City of Sandy

Planning Commission Meeting

**Meeting Date: Monday, August 24,
2020**

- 8.1. 19-050 CPA ZC SUB SAP TREE Bull Run Terrace 88 - 614
[19-050 CPA ZC SUB SAP TREE Bull Run Terrace - Pdf](#)
[Letter from Tracy Brown \(received August 20, 2020\)](#)
[Fair Housing Council of Oregon \(August 24, 2020\)](#)
[ODOT comments \(August 24, 2020\)](#)
[Public Comments \(August 14 - August 24 through 3 PM\)](#)

BULL RUN TERRACE SUBDIVISION
PRELIMINARY PLAT MAP
AND SPECIFIC AREA PLAN
 40808 & 41010 HWY 26, SANDY, OR 97055

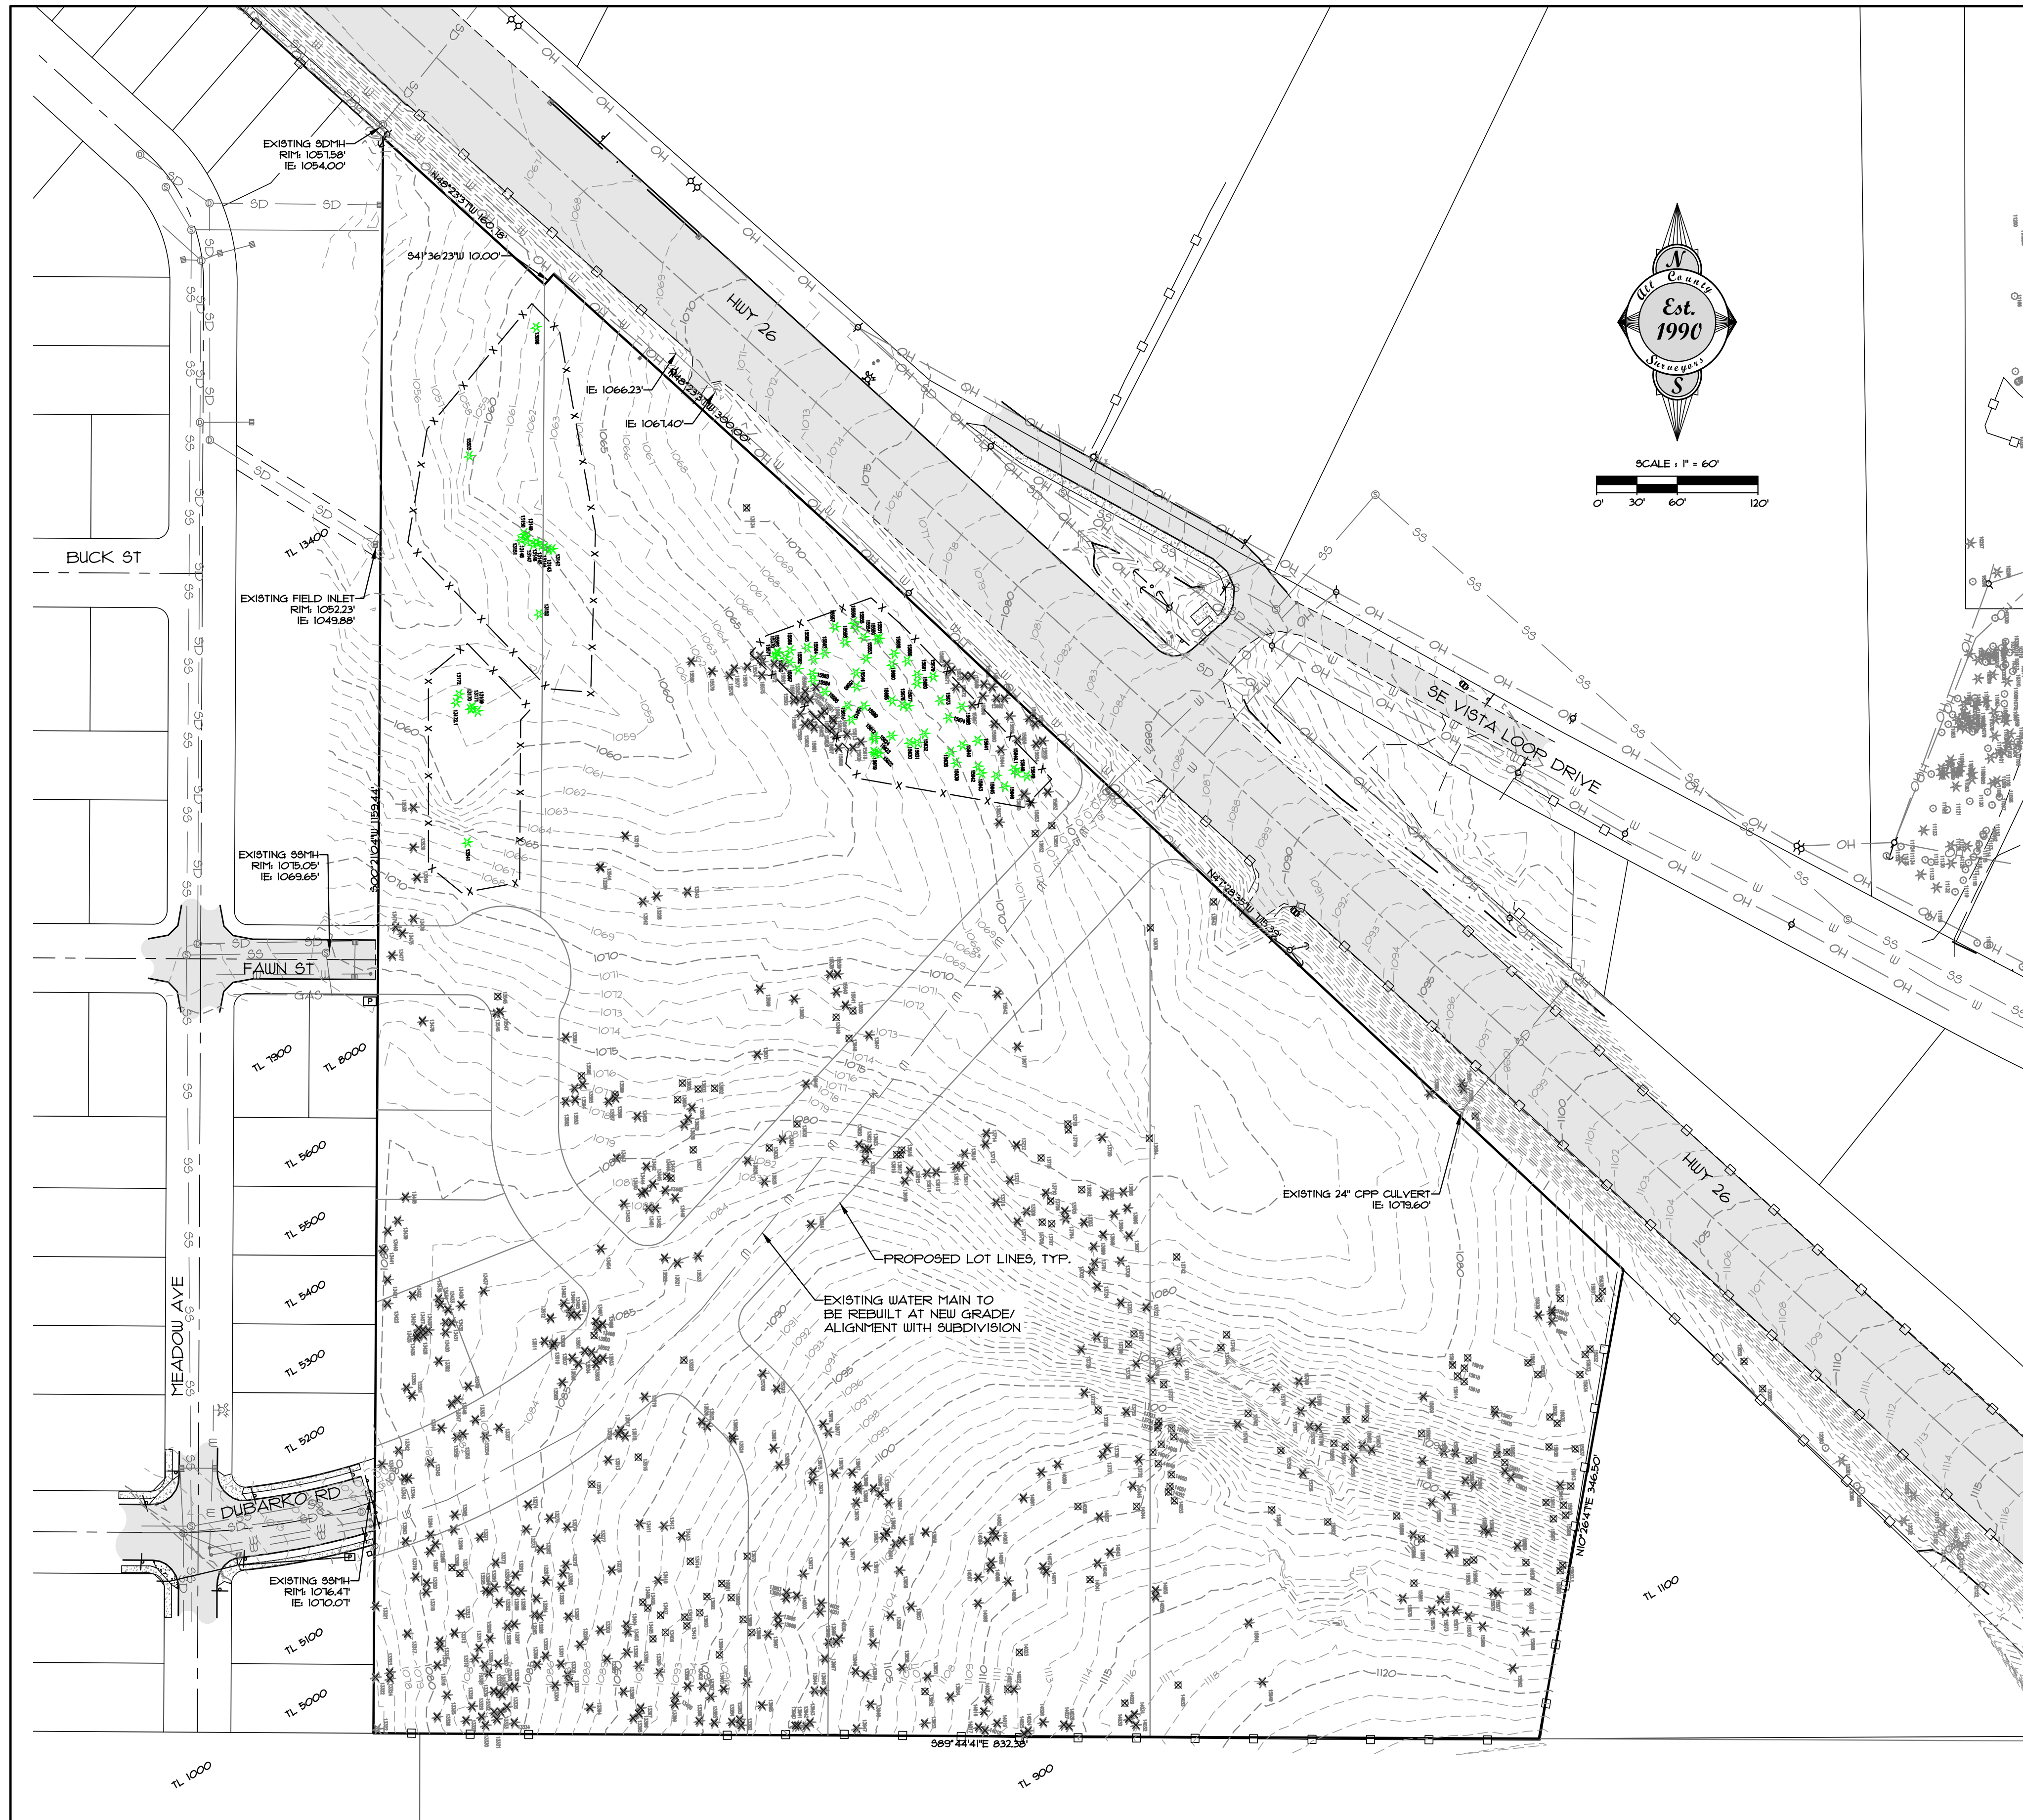
35. Section 17.36.30 contains the design standards for this zone. As shown on Sheet C2 of the plan set (Exhibit 2), all lots in the proposed subdivision contain at least 5,500 square feet, have at least 20 feet of street frontage, and contain an average lot width of at least 50 feet as required. Lot 4 has frontage on Dubarko Road, but access is not permitted from this road. Access to this lot will be across an access easement on Lot 3. The proposed building footprints shown on Sheet C2 indicate that all lots are capable of complying with applicable setbacks in the zone. The details of these development standards will be reviewed with the submittal of building permits.

136. A majority of the proposed retention trees are located along Highway 26 in Lot 7, which is proposed to be zoned C-3, Village Commercial. As indicated on the Preliminary Plat (Exhibit C, Sheet C-2), the applicant is proposing to place a conservation easement over an area that encompasses the retention trees along Highway 26, including their critical root zones. Staff believes there could be a future conflict between retention trees along the Highway and future commercial property visibility on Lot 7. Thus, staff recommends the retention trees be placed into a separate tree retention tract. **The applicant shall update the site plan to detail the retention trees along Highway 26 in a separate tree preservation tract.**
